Summary of Changes

Narrative

RE: **5-DR-2018**
Taco Bell
6P649 (Key Code)

The Planning & Development Services Division has completed the review of the above referenced development application submitted on 8/5/2022. The following **2nd Review Comments** represent the review performed by our team and is intended to provide you with guidance for compliance with city codes, policies, and guidelines related to this application.

C-111

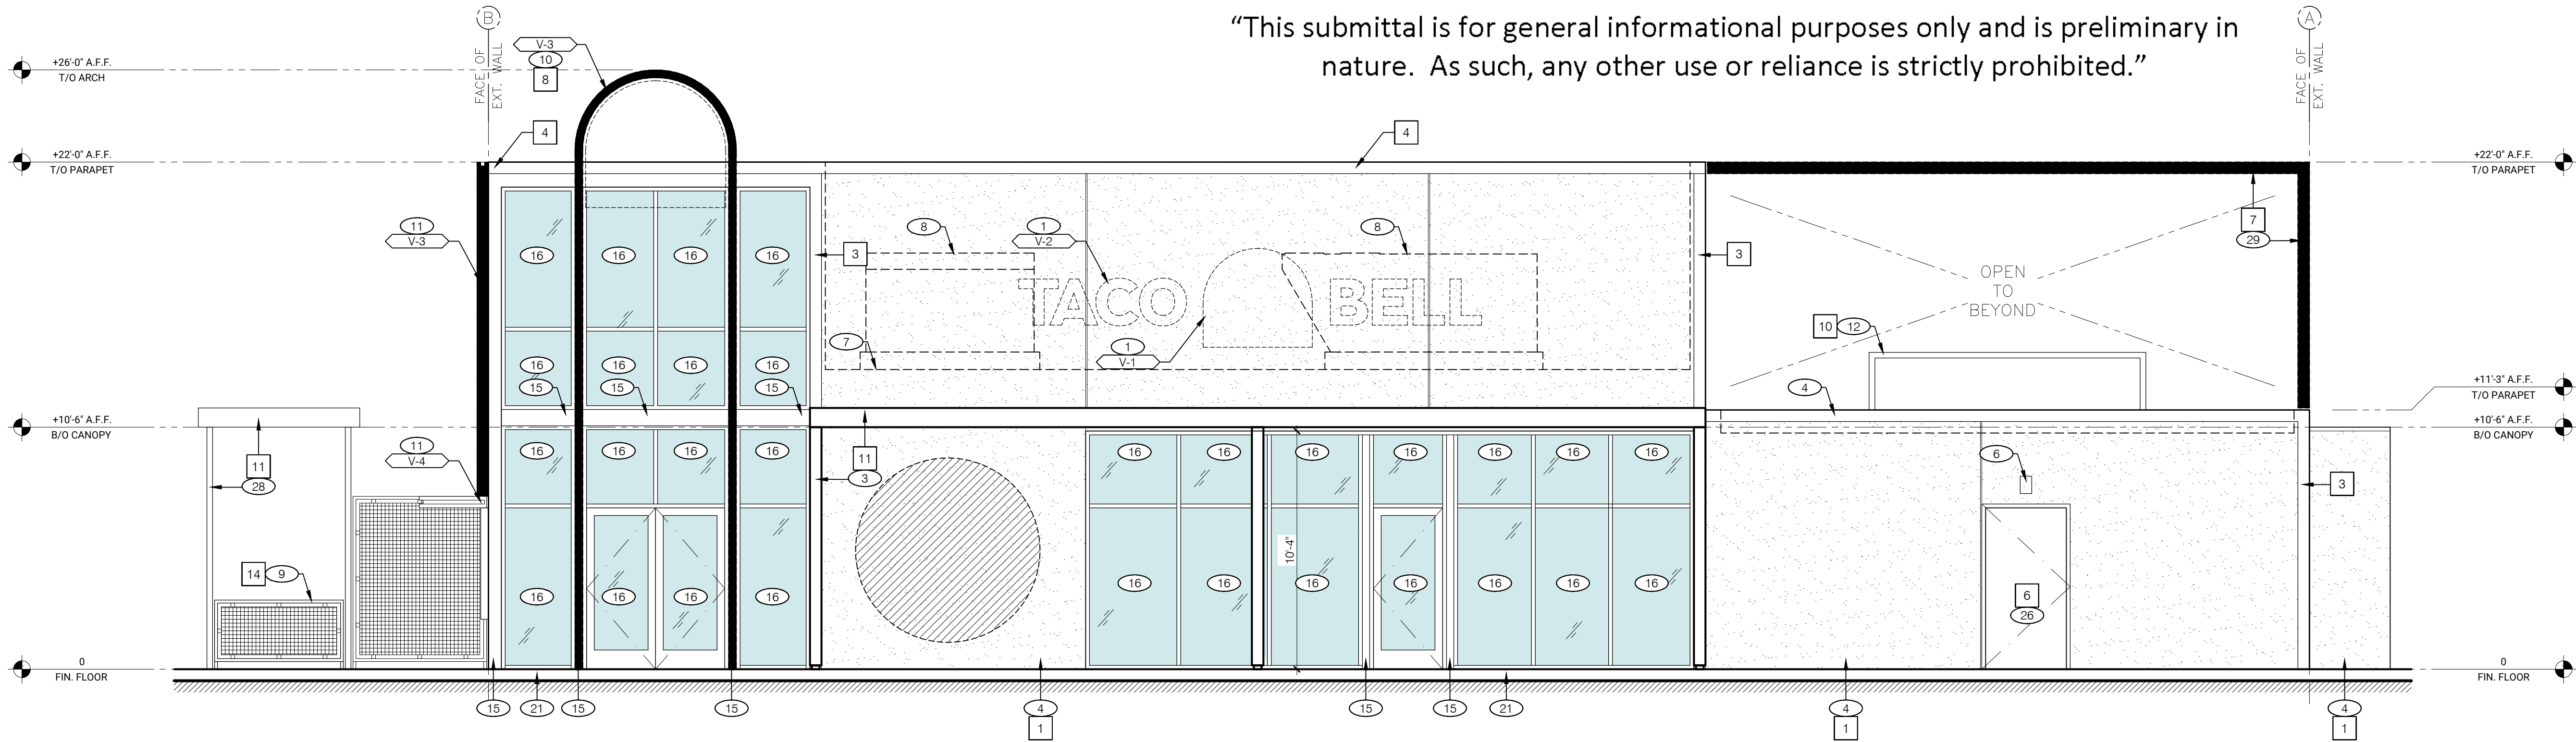
5. Please revise the site plan to show the lot boundaries per the recently approved plat (plan check #2727-20).

Site:

1. Building footprint has changed.
2. Primary sidewalk connection proposed along 79th St. only.
3. Front retention basins conflict with previously shown walls and sidewalk connection with respect to percolation results and area required. Proposed standard curb/gutter with drainage curb openings.
4. Proposed southern retention basin with drainage curb openings.
5. Revised all western facing parking for parking facing building.
6. Revised exterior lighting locations and specifications.
7. All curbs proposed to be curb/gutter.
8. Proposed electrical transformer at building rear.
9. Proposed monument sign along McDowell Rd.
10. Bike rack location revised to near rear elevation.
11. Landscape design has been revised, including species selection.
